10 CFR PART 21 COMMUNICATION

Dresser CAR: ATS 808

Subject: 10 CFR Part 21 Report for Dresser LLC (Masoneilan) Valves with Screwed
Baffle Design

Picture 1

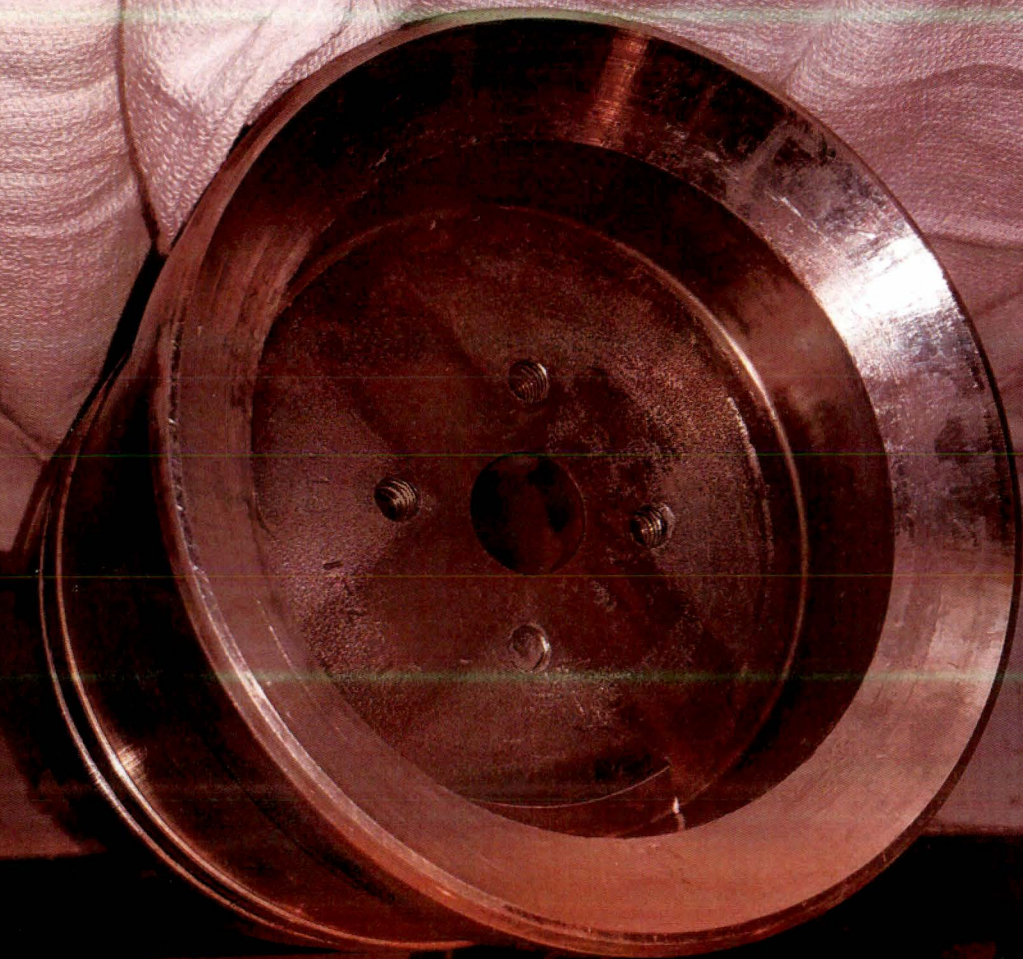
The original plug contained within N00207-8-1 had a screwed baffle plate design secured by four torqued and tack welded socket head screws, which was the Masoneilan standard offering until the end of 1980. After 1980 Masoneilan began to do a full 360 tack weld around the baffle screws. This practice continued until about 1987 when Dresser ceased all production of the screwed baffle design and replaced it with an integral design.

Around 1980 it was shown that we had some issues in vapor, gas, steam service where the baffle was coming undone due to vibration. It was determined by Dresser to remove the baffle from all service except for liquid application. If the customer didn't know the service you wouldn't get a baffle. Additionally, in water applications the tack weld around the baffle retaining screws was enhanced to a full 360 weld and the material was standardized to better stainless steel.

Picture 6

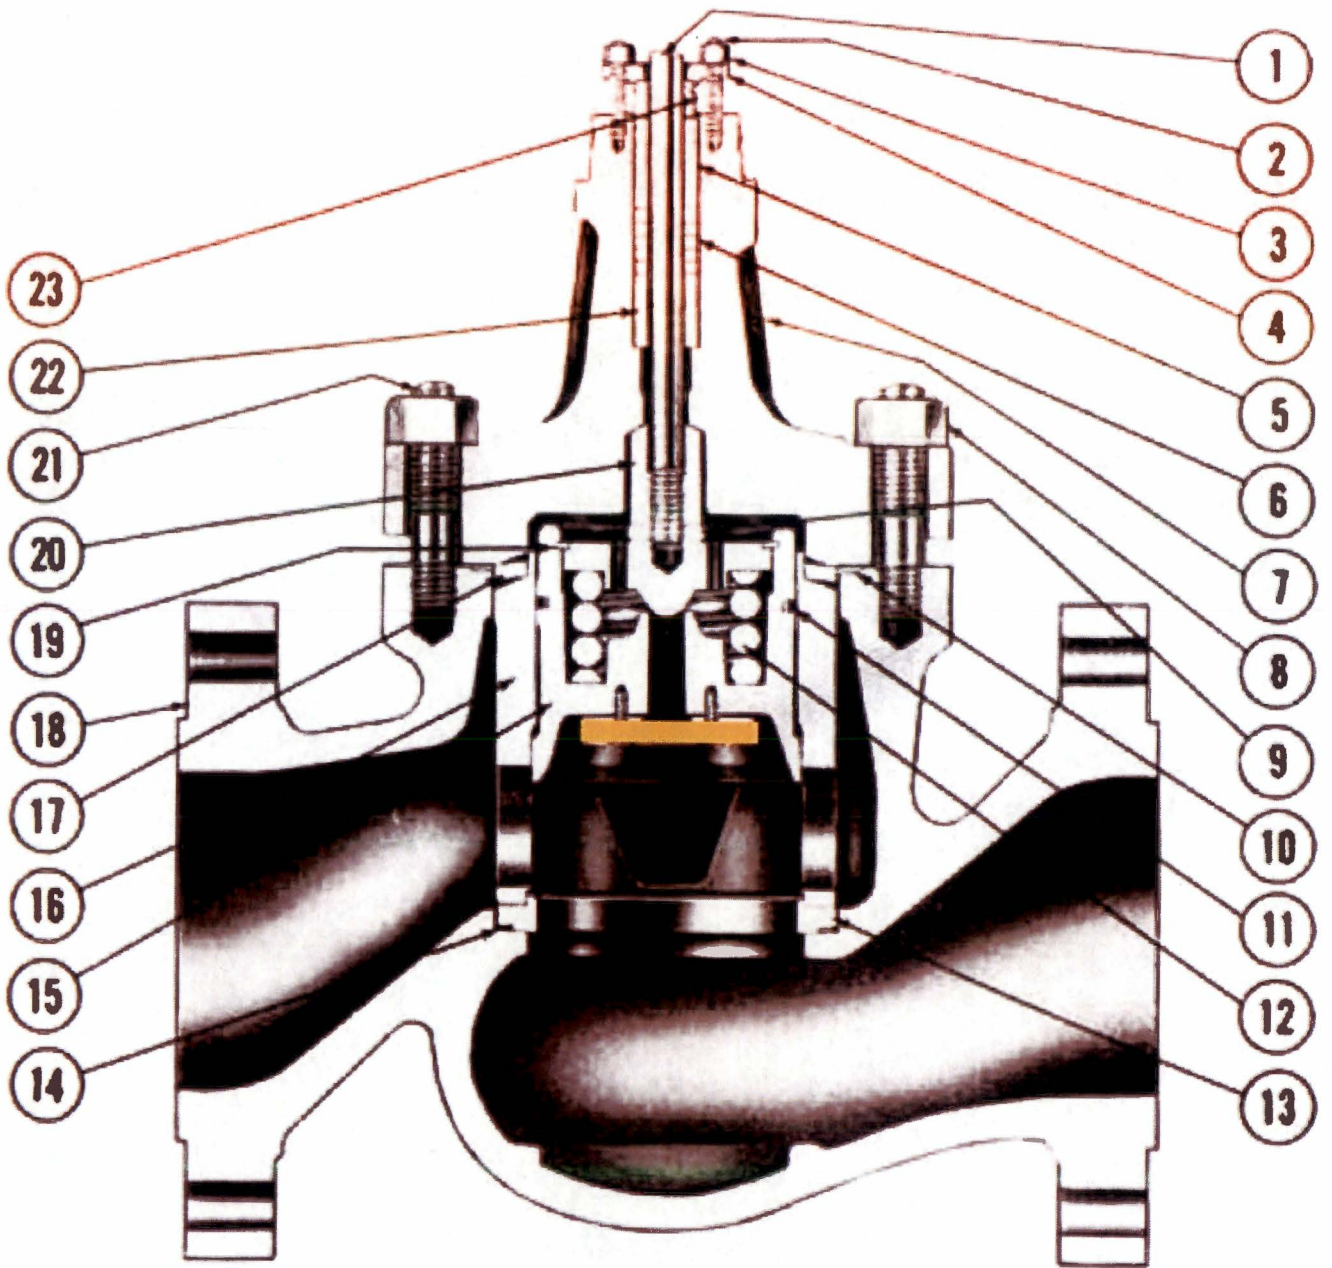
In 1987 it was decided to cease all production of the screwed baffle and go fully to the integral design. After which all the pilot trim design have the integral baffle.

From 1987 to present day, any request to Dresser for nuclear replacement parts that originally contained the screwed baffle design are quoted with the part number of the integral design.
